HARRISVILLE CITY

Harrisville City Planning Commission

Harrisville City Offices
Wednesday, July 10, 2024

AGENDA

GARDNER GROVE SUBDIVISION

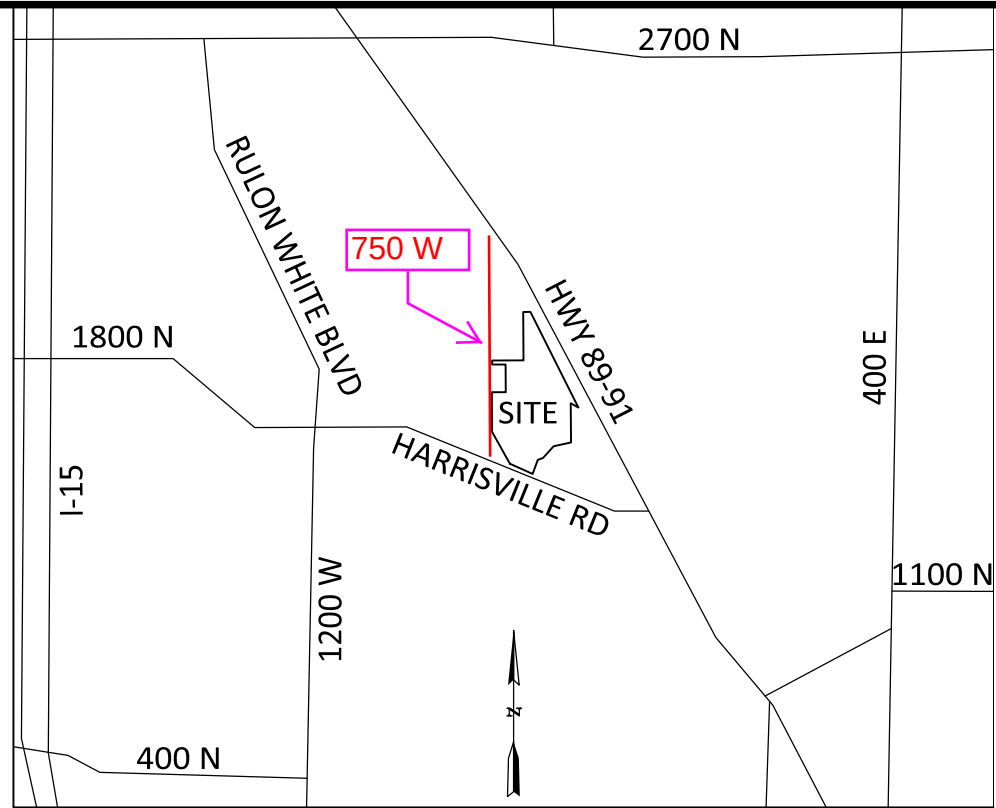
5. The proposed land swap with the Vasas family will need to be finalized and they will need to sign the plat as property owners in the subdivision.
6. Show the existing ponds and ditches and any wetland delineations on the plat.

7. If the proposed public street, "Lorriane Lane", isn't going to be constructed at this time, consider leaving it off the plat and adding it later with a subdivision amendment or new subdivision.

8. Provide lot addresses on the plat as provided by our office.

DON'T CLOSE OR
MATCH UP WITH THE
DRAWING - REVISE
AND UPDATE

TO: Harrisville City Planning Commission
FROM: Matt Robertson, City Engineer
**RE: HEAVENLY ROADS SUBDIVISION
Preliminary Plat Submittal**
Date: July 3, 2024

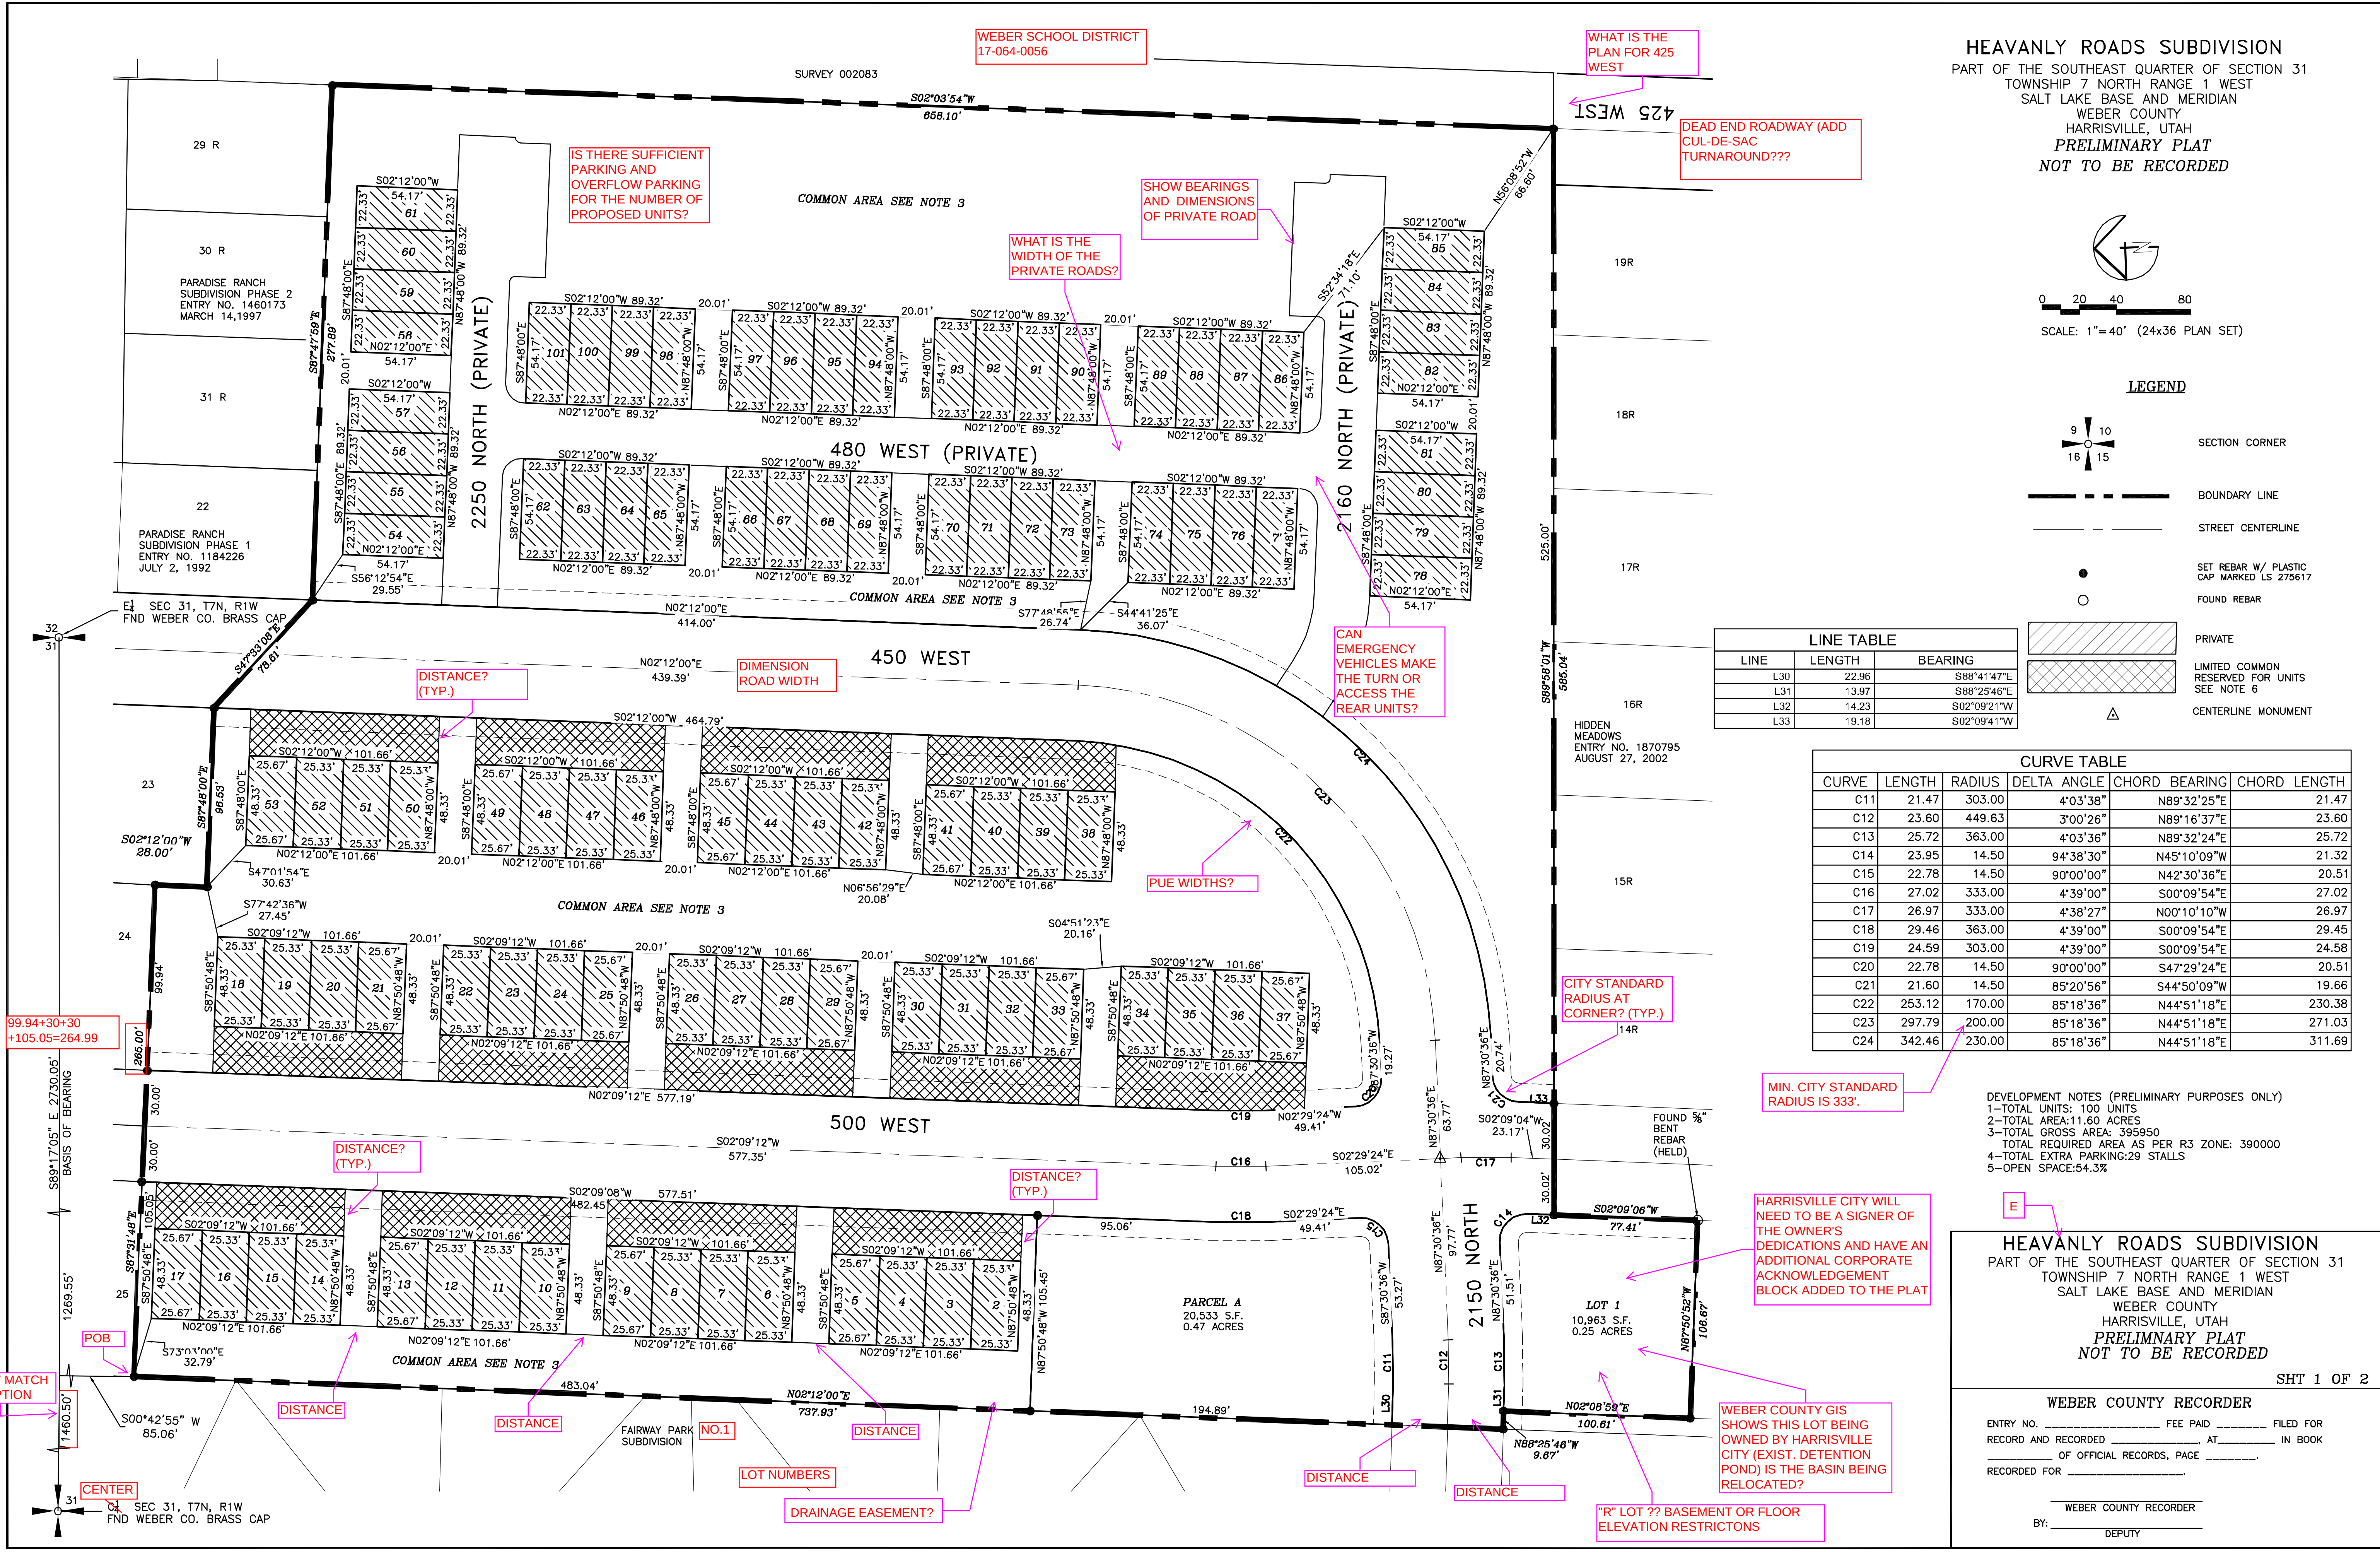
2. Resolve all red-line comments provided by our office on the preliminary plat.
3. Ensure that the private drives are wide enough and provide turning space for emergency vehicles (approval to be obtained from North View Fire District).

4. Provide additional parking in the private area as required by the City to encourage parking within this area and not on the city street.
5. Include the dimensions and locations of the public utility and drainage easements and any other required easements associated with the utilities or ditches on the property.

7. Provide lot addresses on the plat as provided by our office.

SITE & UTILITY PLAN FOR

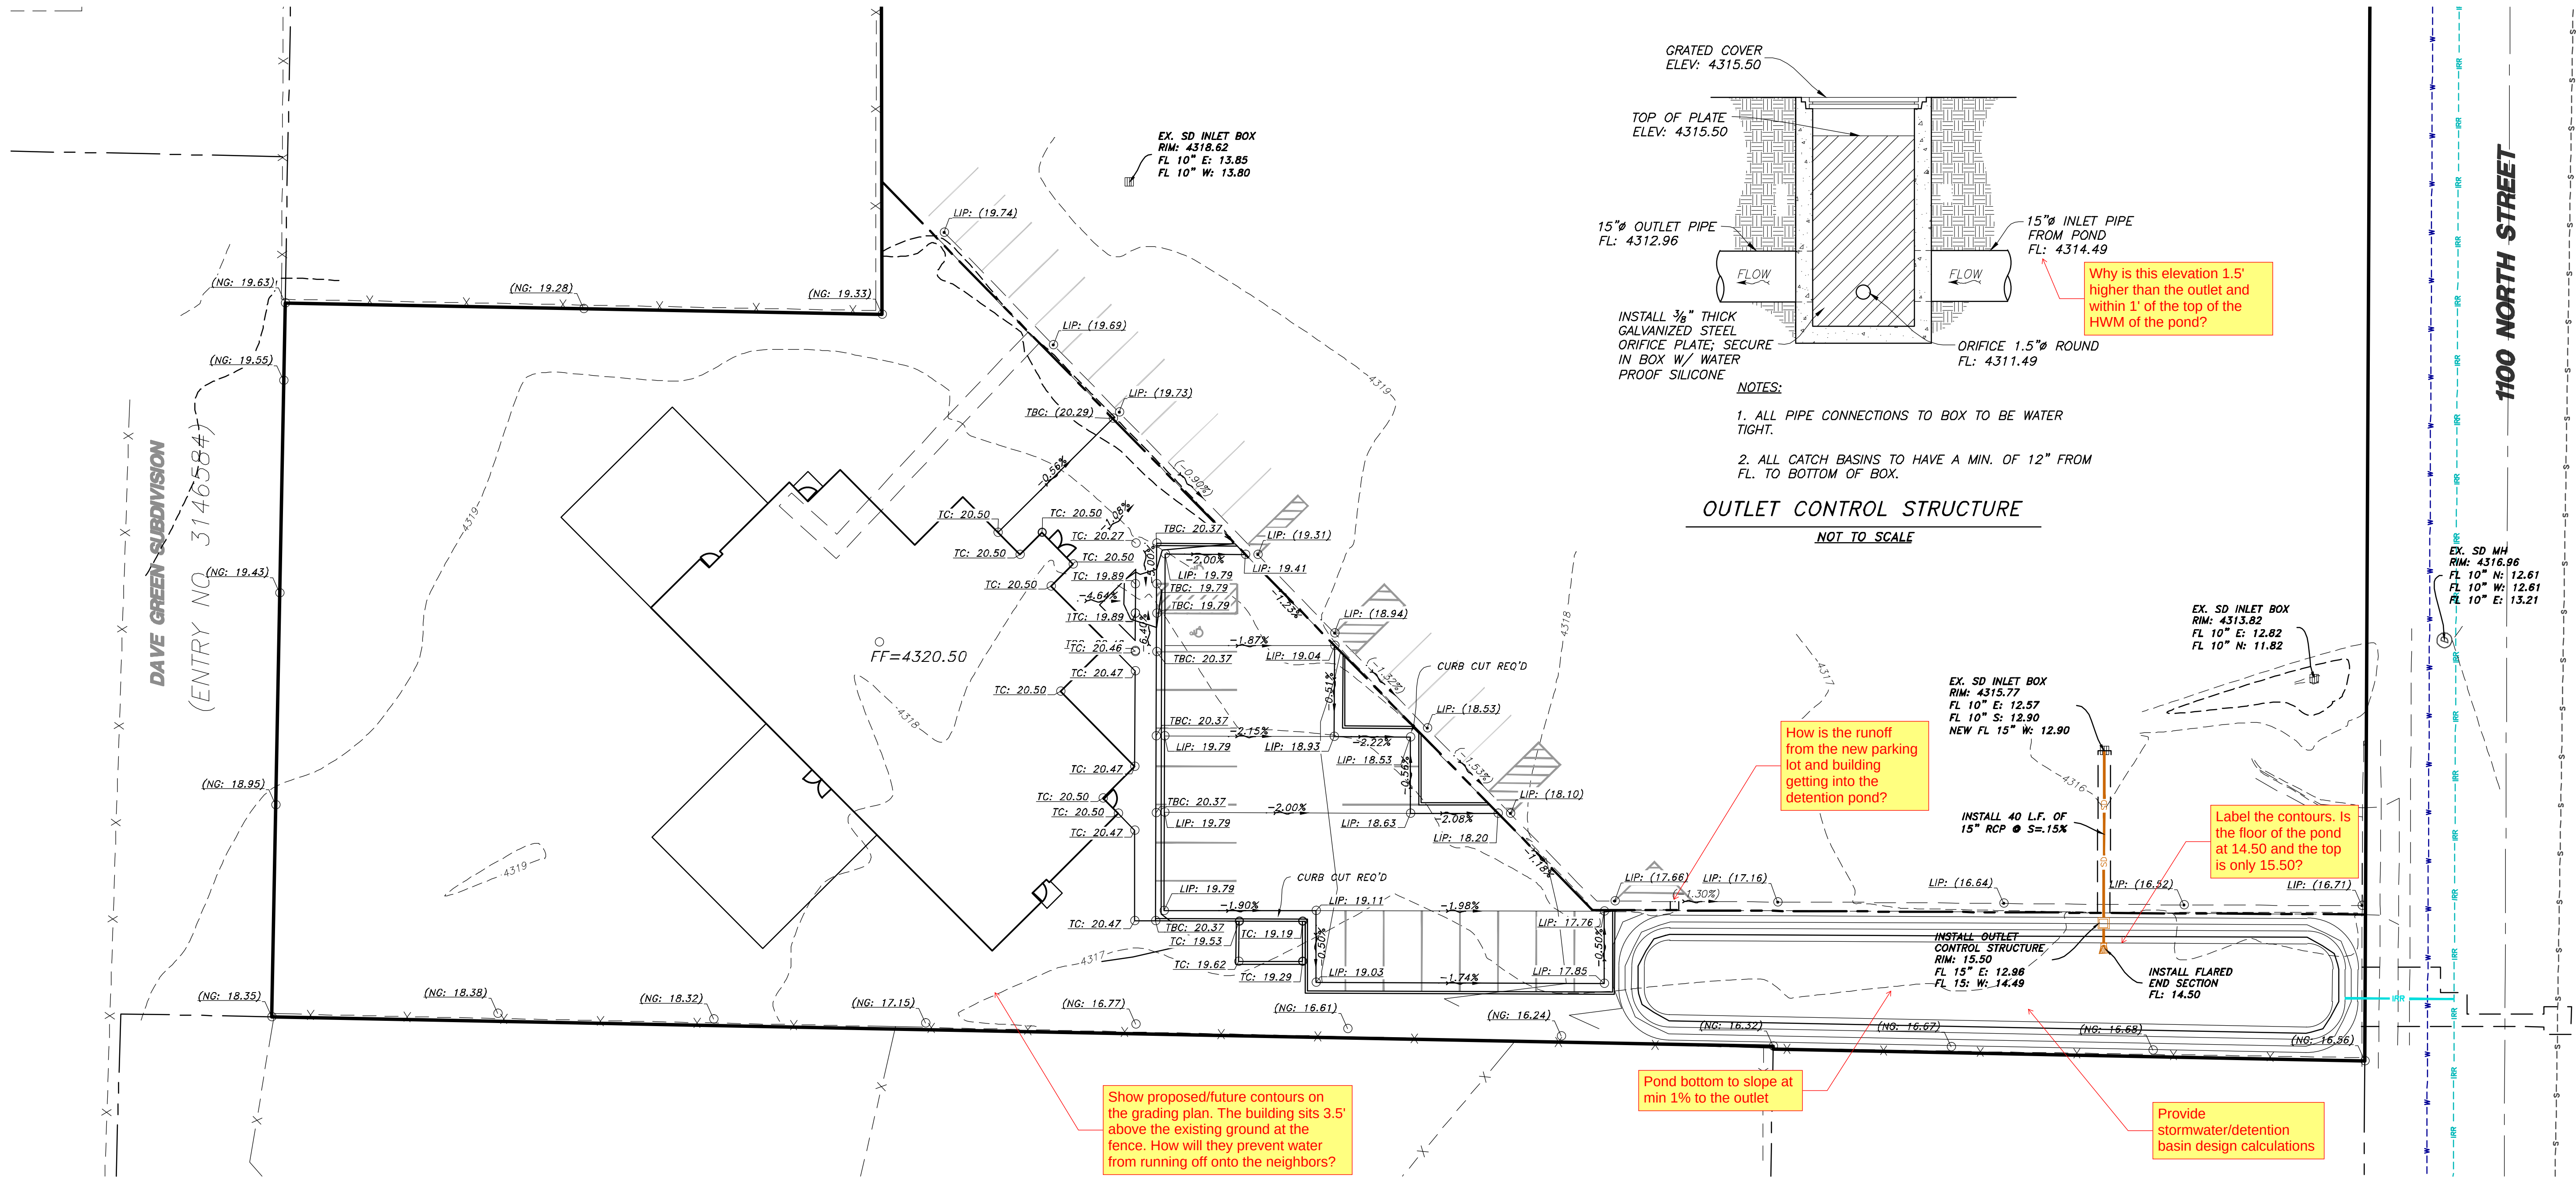
3. Provide a landscape plan for the new site.
4. Update the sewer plan to show a 4" sewer lateral being run from the building if the sewer elevation can be raised at the building. The 4" lateral should connect to the main without a manhole. See red-line comments on the plans.

6. Remove the striping of existing parking stalls at the entrances to the new parking lot.
7. Show the proposed contours on the grading plan and show how runoff will be kept on the site and not flow onto the neighboring properties to the west, particularly near the southwest corner of the new building.

GRADING PLAN FOR
FAMILY PROMISE
1103 N WASHINGTON BLVD
HARRISVILLE, WEBER COUNTY, UTAH
A Part of the Southeast Quarter of Section 5
Township 6 North, Range 1 West, S.L.B.&M.

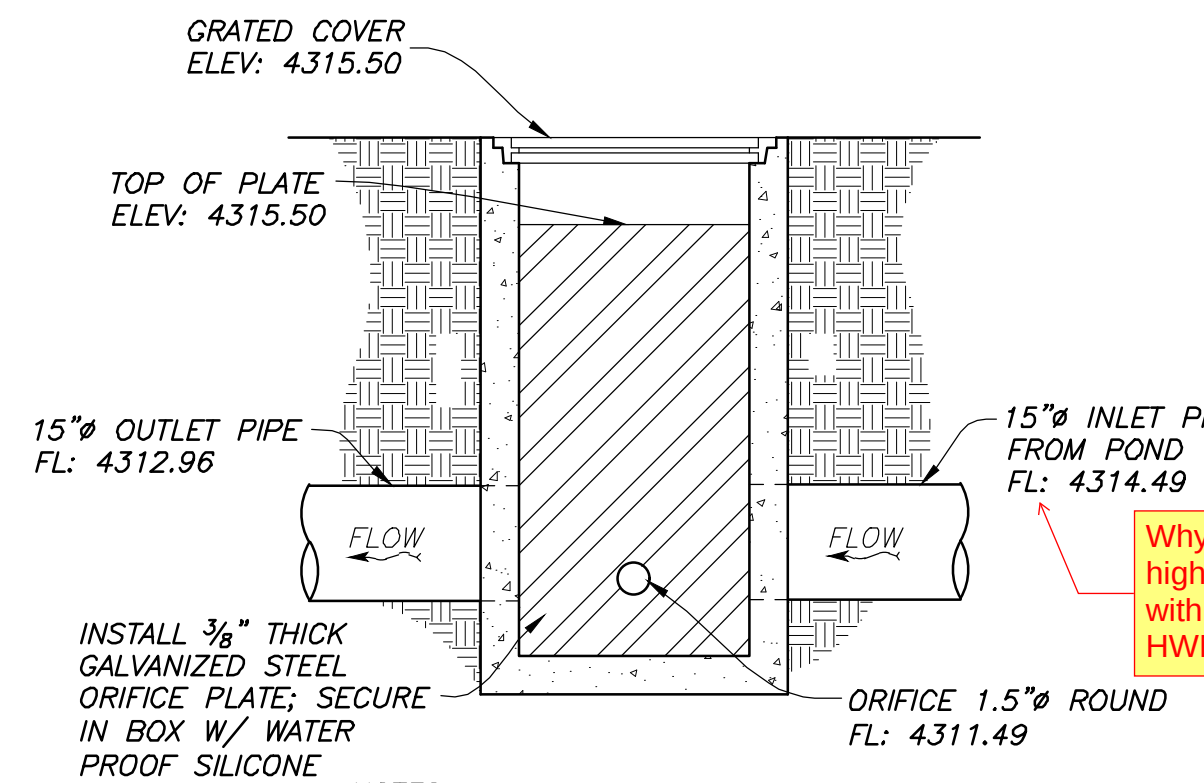
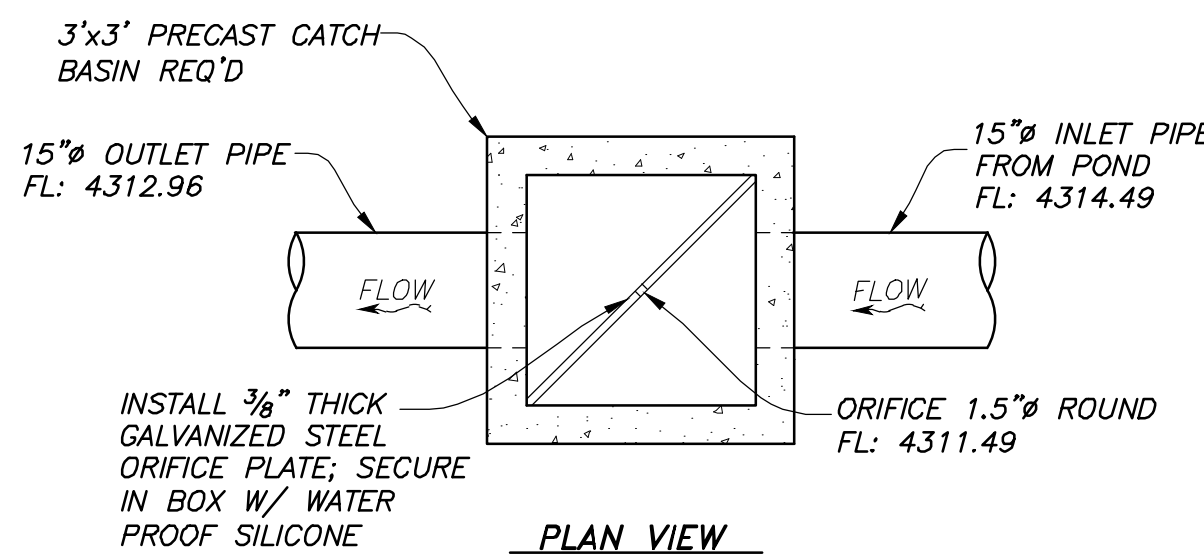
8. Show how the parking lot runoff will be directed to the detention basin and make sure that the floor of the detention basin has a minimum 1% slope to the outlet.

9. Show the detention basin calculations and clarify the elevations of the outlet pipe and the elevations of the basin bottom and top.
10. Provide screening between the commercial zone per Section 11.13.050 of the City Code.

Provide stormwater/detention basin design calculations
